UNITED STATES PATENT AND TRADEMARK OFFICE

APPLICATION NO.	FILING DATE	FIRST NAMED INVENTOR	ATTORNEY DOCKET NO.	CONFIRMATION NO.
10/751,722	01/05/2004	Bobby Hu	2186-00500 DVF	2253
23505	7590	09/25/2006	EXAMINER	
CONLEY ROSE, P.C. P. O. BOX 3267 HOUSTON, TX 77253-3267			SHAKERI, HADI	
			ART UNIT	PAPER NUMBER
			3723	
DATE MAILED: 09/25/2006

Office Action Summary

DETAILED ACTION***Continued Examination Under 37 CFR 1.114***

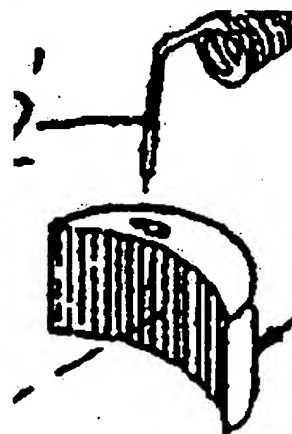
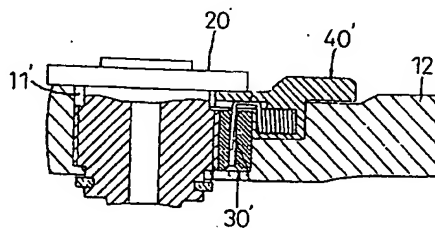
AAPA, e.g., Figs. 10 and 11 discloses all the limitations of claims 1 and 9, i.e., a handle; a head extended from the handle; a cavity disposed in a web between the handle and the head; a compartment disposed in the web having one end communicated with the pawl and a second end communicated with outside; a drive member (20') rotatably mounted in the head, with the drive member including a plurality of teeth formed on an outer periphery thereof; a sliding pawl (30') including a first side with a plurality of ratchet teeth for releasably engaging with the teeth of the

drive member, with the sliding pawl further including a second side with a recess (accommodating 442') the recess being defined by an elliptical wall having first and second portions (facing the sides of the tool); a rotatable switch member (40') including a turn-piece for manual operation and an actuating plate extended from the turn-piece, the switch member being switchable between two positions for changing ratcheting direction of the drive member, with the actuating plate of the switch member including a first receptacle that faces the recess of the pawl; a biasing means (44') engaged between the receptacle in the switch member and the recess in the pawl, operable to urge the pawl into engagement with the drive member by alternatively engaging the first and second portions of the wall.

Regarding claims 2, 5, 7-10, 13, and 15-18, AAPA meets the limitations, i.e., the biasing means including an elongated member (442') having a first end engaged with the recess in the pawl and a second end engaged with the receptacle (either thru the coiled section or directly right at the first end of the receptacle) and an elastic member (coiled section); and the pawl having a curved second side; the pawl having a third wall portion intermediate the other portions (i.e., porting facing the drive member or the portion facing the handle).

8. Applicant's arguments filed August 10, 2006 have been fully considered but they are not persuasive. The argument that AAPA fails to indicate a recess defined by a wall is incorrect. An elliptical wall defines the recess in AAPA and in order for the biasing means to actuate the pawl it would have to act on a portion of the wall in the same direction of actuation.

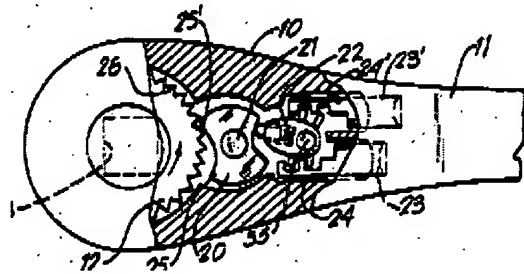
Deibert meets all the limitations of the above claims 1 and 9, as indicated in the previous office action, except for a sliding pawl, a modification considered obvious to one of ordinary skill in the art, in enhancing the operation, to save manufacturing cost and/or for ease of assembly.
